UNITED STATES PATENT AND TRADEMARK OFFICE

APPLICATION NO.	FILING DATE	FIRST NAMED INVENTOR	ATTORNEY DOCKET NO.	CONFIRMATION NO.
10/543,080	07/21/2005	Marco Pontanari	60130-2399; 02MRA0191	2571
26096 7590 02/21/2007 CARLSON, GASKEY & OLDS, P.C. 400 WEST MAPLE ROAD SUITE 350 BIRMINGHAM, MI 48009			EXAMINER KNIGHT, DEREK DOUGLAS	
			ART UNIT	PAPER NUMBER
			3681	
SHORTENED STATUTORY PERIOD OF RESPONSE		MAIL DATE	DELIVERY MODE	
3 MONTHS		02/21/2007	PAPER

Office Action Summary

DETAILED ACTION

Figure 1: Taken from Figure 1 of KELLER (US 5,030,181)

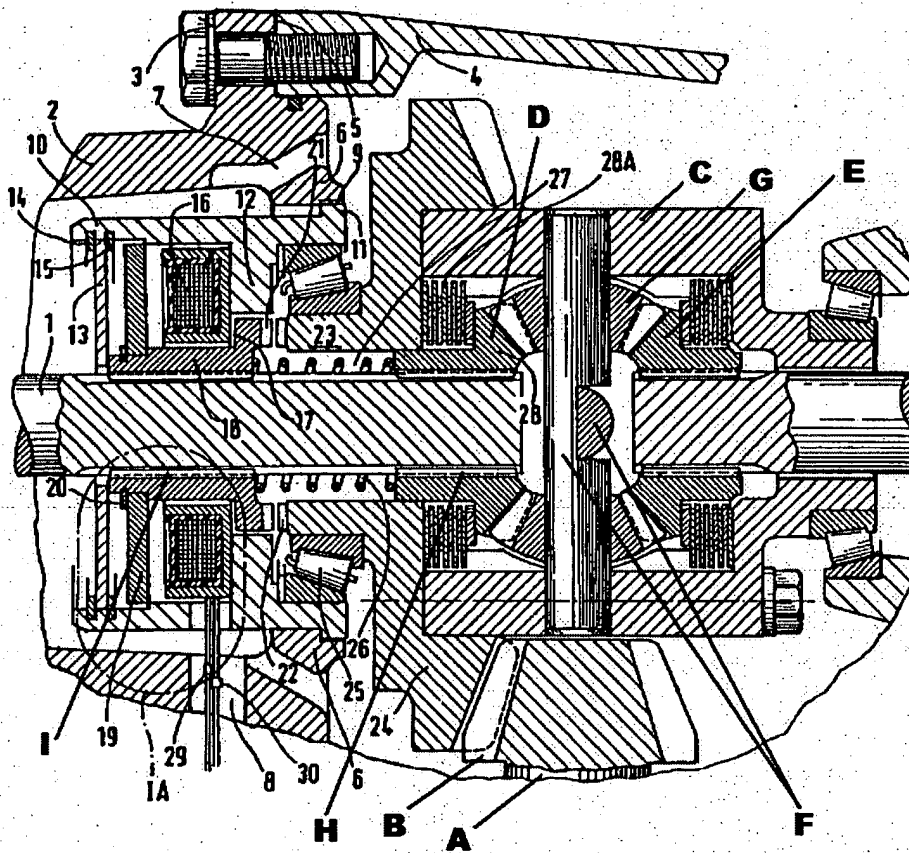
Please note that Figure 1 below has added reference letters to help identify features shown in **KELLER (US 5,030,181)**.

Regarding claims 1 and 9: **KELLER** discloses a drive axle assembly with a locking differential comprising a driving input (A), a carrier (C) including a pinion gear (B) driven by the driving input and a ring gear (24) in meshing engagement with said pinion gear a differential including a differential gear assembly supported within a differential case (24 and C); a pair of axle shafts (1) driven by the differential gear assembly for rotation about an axis; a locking mechanism including a shift collar (18) movable between an unlocked position where speed differentiation between said pair of

axle shafts is permitted and a locked position wherein said shift collar (18) directly engages the differential case (24) such that said differential case, said shift collar, and said pair of axle shafts are fixed for rotation together; and an electronic actuator (16) for generating an electronic signal to move the shift collar from said unlocked position to said locked position.

Regarding claims 2 and 10: KELLER shows the electronic actuator (16) including a coil (not numbered) mounted to an axle component (2) and surrounding the shift collar (18) wherein an electronic signal powers the coil to move the shift collar.

Regarding claim 3 and 14: KELLER shows the differential case (24 and C) includes a first case half (24) and a second case half (C) and the electronic actuator (16) selectively moves the shift collar to engage one of the case halves.

Regarding claim 4: KELLER shows a resilient member (26) for automatically returning said shift collar to the unlocked position when the coil is not powered.

Regarding claim 6: KELLER shows a washer (19) fixed to the outboard end of the shift collar. Although Keller does not show it, the washer is capable of reacting with a resilient member. Using the washer to react with a resilient member is simply intended use.

Regarding claim 7,8, and 12: KELLER shows the shift collar including an inboard end having a splined surface (21) and an out board end capable of supporting a resilient return member, the inboard end having a greater diameter than the outboard end. The coil defines a central bore surrounding the shift collar at the outboard end, said shift collar moving in an inboard direction in response to said coil being powered

via an electronic signal such that the splined surface (21) of the inboard end engages a mating splined surface (22) formed on said differential case (24) such that the differential case is locked to the pair of axle shafts.

Regarding claim 11: KELLER shows an axle housing (2) for substantially enclosing said carrier (C) and said pair of axle shafts (1) wherein said coil is supported by the axle housing.

Regarding claim 15: KELLER shows a pair of side gears (D and E) with one side being fixed to each of said pair of axle shafts and wherein said differential gear assembly includes a differential spider (F) having for support shafts oriented in an overall shape of a cross and four pinion gears (G), only 2 are shown in Figure 1 below, in meshing engagement with said side pair of gears with one of said four differential pinion gears being supported on each of said four support shafts and wherein said ring gear (24) is fixed to one of said first and second case halves such that said ring gear, said differential case, said differential spider, and said four differential pinion gears all rotate as one unit to transfer power to said pair of axle shafts via said pair of side gears when no speed differentiation is required and when speed differentiation is required said four differential pinion gears rotate on respective support shafts to speed up rotation of one of the pair of axle shafts via a respective one of said pair of side gears while slowing rotation of the other of said pair of axle shafts via a respective other said pair of side gears.

Regarding claim 16: KELLER shows one of said pair of axle shafts including a set of inboard splines (H) and a set of outboard splines (I), said set of inboard splines

cooperating with said respective one of said pair of side gears to fix said one of said pair of side gears for rotation with said one of said pair of axle shafts and said set of outboard splines cooperating with a splined bore formed inside said inboard of said shift collar.
